UNITED STATES PATENT AND TRADEMARK OFFICE

10/522,931

| Office Action Summary | Application No. 10/522,931 | Applicant(s) LOSCH, ALFRED | |

DETAILED ACTION

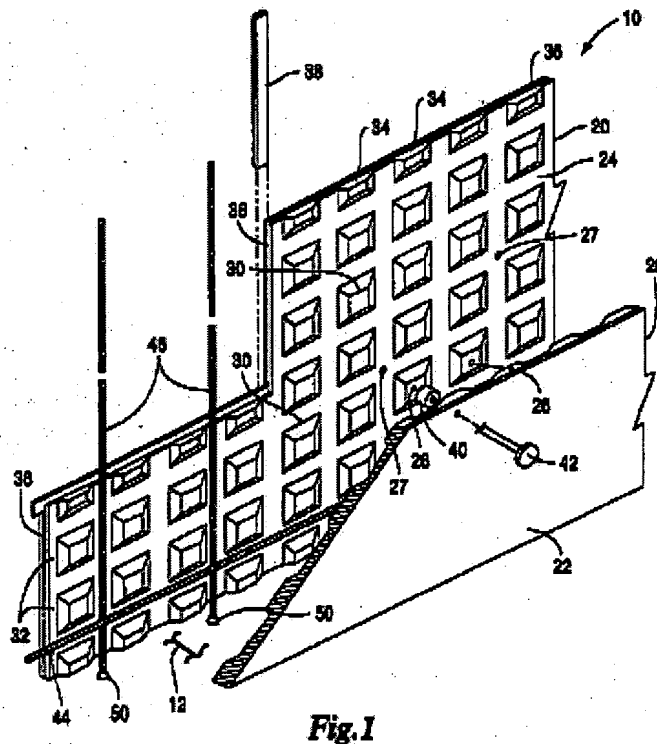
Claims 1 and 5 are rejected under 35 U.S.C. 102(e) as being anticipated by Pub. No. US/20060010831 A1 Skakie.

With respect to claim 1, Skakie discloses a connection (Fig. 1) of edges of formed sheets (20), wherein the edges of said sheets (20) have at least partially planar contact and can be detachably connected with one another, a first sheet (20, the front sheet) with an edge comprising a plurality of mounts (30) arranged thereon; a second sheet (20, the rear sheet) with an edge, said second sheet (20) comprising a plurality of mounting flanges (30), said first and second sheets (20) being positioned such that each mounting flange (30) is in flat contact with each mount (30); a clamping strip (40) providing a detachable connection of said sheets (20) at said mounts (30) and mounting flanges (30); and a screw (42) connection for connecting said clamping strip (40) and said mounts (30) and mounting flanges (30) of said sheets (20).

With respect to claim 5, Skakie discloses (Fig. 1) that clamping strip (40) and edges of the sheets (20) to be contacted to one another are connected to one another by means of the screw connection (42).

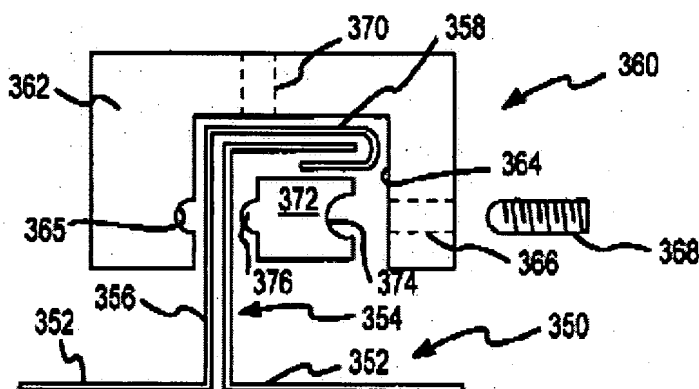
Claims 1, 2, and 5-9 are rejected under 35 U.S.C. 103(a) as being unpatentable over US Patent No. 7,100,338 Haddock in view of Pub. No. US/20060010831 A1 Skakie.

With respect to claim 1, Haddock discloses a connection (360, Fig. 9) of edges of formed sheets (352), wherein the edges of said sheets (352) have at least partially planar contact and can be detachably connected with one another; a clamping strip (362) providing a detachable connection of said sheets (352); and a screw (368) connection for connecting said clamping strip (362) and said sheets (352); wherein said clamping strip (362) has at least partly a U-shaped design; wherein the clamping strip (362) has a metal core; and wherein the clamping strips (362) and said edges of said sheets (352) to be connected to one another are connected to one another by means of said screw connection (368). Haddock does not disclose that the connection with an edge comprising a first sheet including a plurality of mounts arranged thereon; a second sheet (352) with an edge, said second sheet comprising a plurality of mounting flanges, said first and second sheets being positioned such that each mounting flange is in flat contact with each mount. Skakie teaches a connection (Fig. 1) comprising a first sheet (20) with an edge comprising a plurality of mounts (30) arranged thereon; a second sheet (20) with an edge, said second sheet (20) comprising a plurality of mounting flanges (30), said first and second sheets (20) being positioned such that each mounting flange (30) is in flat contact with each mount (30). It would have been obvious to one of ordinary skill in the art at the time of invention was made to the first and second sheets of Haddock with a plurality of mounts and flange mounts with flat contact with other in order to provide the separator with ability of withstanding side stresses.

With respect to claim 2, Haddock discloses (Fig. 9) that the clamping strip (362) has a partially a U-shaped design.

With respect to claim 5, Haddock discloses a connection (Fig. 9) that the clamping strips (362) and said edges of said sheets (352) to be connected to one another are connected to one another by means of said screw connection (368).

With respect to claim 6, Haddock discloses a connection (Fig. 9) further comprising a joint sealing (constituted by a recess 365) is also connected together with said clamping strip (362) and said edges of said sheets (352) to be connected by means of a screw connection (368).

With respect to claims 7-9, Haddock discloses (Fig. 9) that a joint sealing (365) is integrated in said clamping strip (362); and wherein the clamping strip is designed as a cover strip; and wherein the clamping strip (362) extends at least partially over the circumference of edges of the sheets (352).

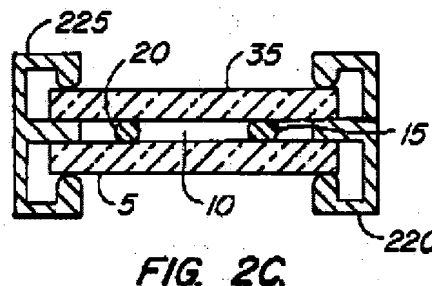
With respect to claims 3 and 4, Haddock discloses the claimed invention except that the clamp strip is consists of a plastic. Bright teaches a clamp (25, Fig. 7) consists of a plastic; and wherein the clamp strip (25) has a metal core (28C). It would have been obvious to one of ordinary skill in the art at the time of invention was made to form the clamp of Haddock from plastic with a metal core as taught by Bright in order to provide a clamp with a draught and weatherproofing function.
